Appendix A

Initial Study, Notice of Preparation and
Responses to the Notice of Preparation

NOTICE OF PREPARATION

PROJECT TITLE: Gateway South Specific Plan, General Plan
Amendment and Rezoning.

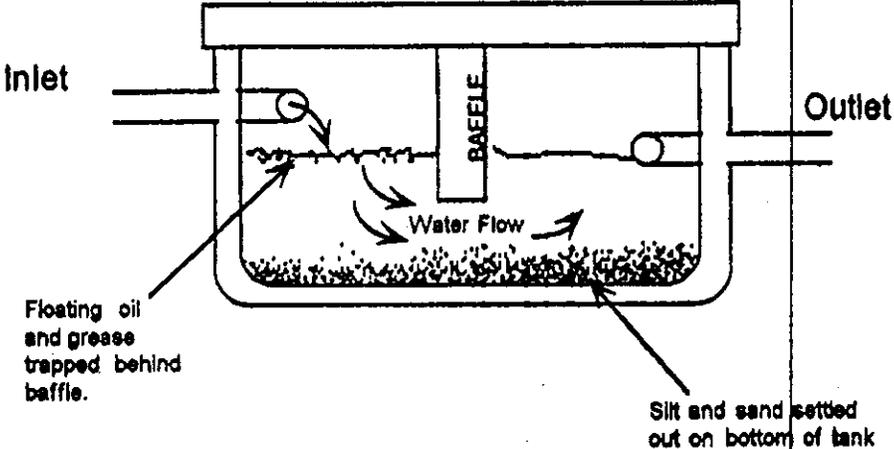
15. The silt and grease traps recommended for use in treating parking lot run-off combine two treatment elements:
- a. A stilling tank or basin that traps and detains the water to allow sediment to settle out.
 - b. A baffle or barrier that traps floating contaminants such as oil or grease. The baffle is a wall or barrier in the tank with holes at the bottom. The floating debris stays on the water surface and can't pass by the barrier, while clean water flows underneath or through the bottom of the barrier. Newer designs for more critical applications combine a baffle system with absorbent materials or filters that actually trap oil and grease.

The simplest type of silt and grease trap is a traditional septic tank. See drawing of a septic tank design on the following page.
